Well Name: EP USA	Well Location: T26S / R29E / SEC 26 / SESW /	County or Parish/State: EDDY / NM
Well Number: 5	Type of Well: OIL WELL	Allottee or Tribe Name:
Lease Number: NMNM13997	Unit or CA Name:	Unit or CA Number:
US Well Number: 3001525020	Well Status: Producing Oil Well	Operator: WPX ENERGY PERMIAN LLC

Type of Submission: Notice of Intent	Type of Action: Plug and Abandonment
Date Sundry Submitted: 11/29/2021	Time Sundry Submitted: 10:17
Date proposed operation will begin: 12/06/2021

WPX Energy Permian, LLC  
EP - USA 5  
API 30-015-25020  
EDDY COUNTY, NM

Proposed PA WBD

Proposed PA WBD

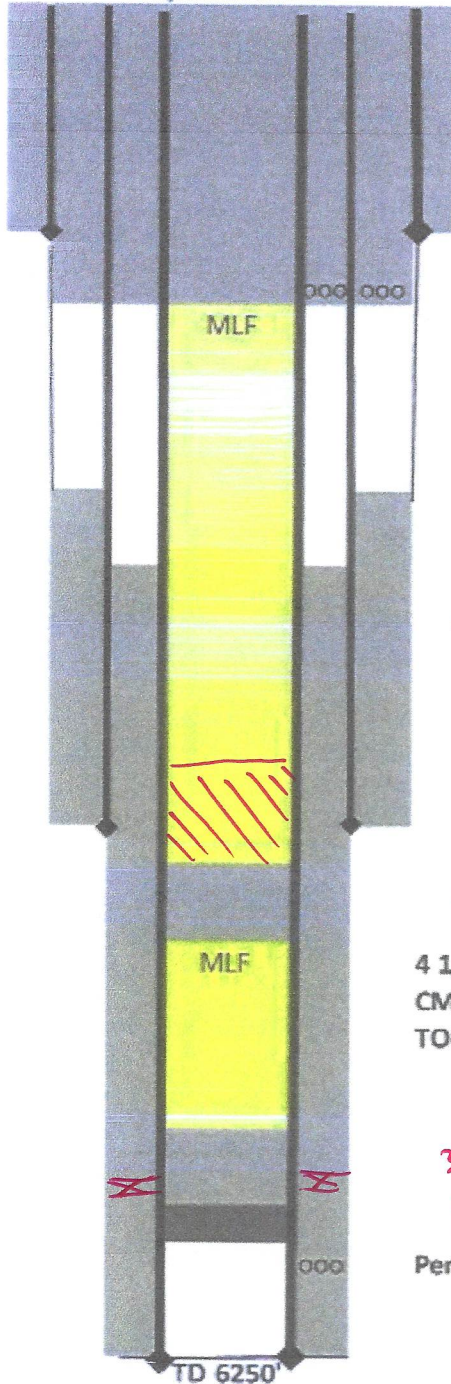
1. Run and set 4 1/2" CIBP @ ~~4250'~~ <sup>4935'</sup> Leak test CIBP
2. Spot ~~25~~ <sup>30</sup> sx Class C cmt on CIBP
3. Displace well with 9.5# gelled brine
4. Spot ~~40~~ <sup>2968'</sup> sx cmt plug at ~~2965~~ <sup>2968'</sup> (Base of Salt 2915') <sup>455x</sup> (2968' to 2376') wacktag
5. Perf Sqz holes ~~502'~~ <sup>600'</sup> Perf 2 strings of casing to surface (in/out)
6. (Top of Salt 550') <sup>360 sx</sup>
7. Establish circulation between 4 1/2" x 8 5/8" & 8 5/8" x 13 3/8" casing
8. Circulate Cmt to surface on all strings of casing
9. Cut off wellheads and leave casing strings full of cement

Perf 502'  
~~600'~~

360 sx (in/out)  
Verify @ surface

Perf & Sep.  
45 sx

~~40 sx cmt plug 2376-2965 BOS~~  
2968'

WOC & TAG

30 sx  
~~25 sx cmt Cap~~  
CIBP 4950'

Leak test CIBP
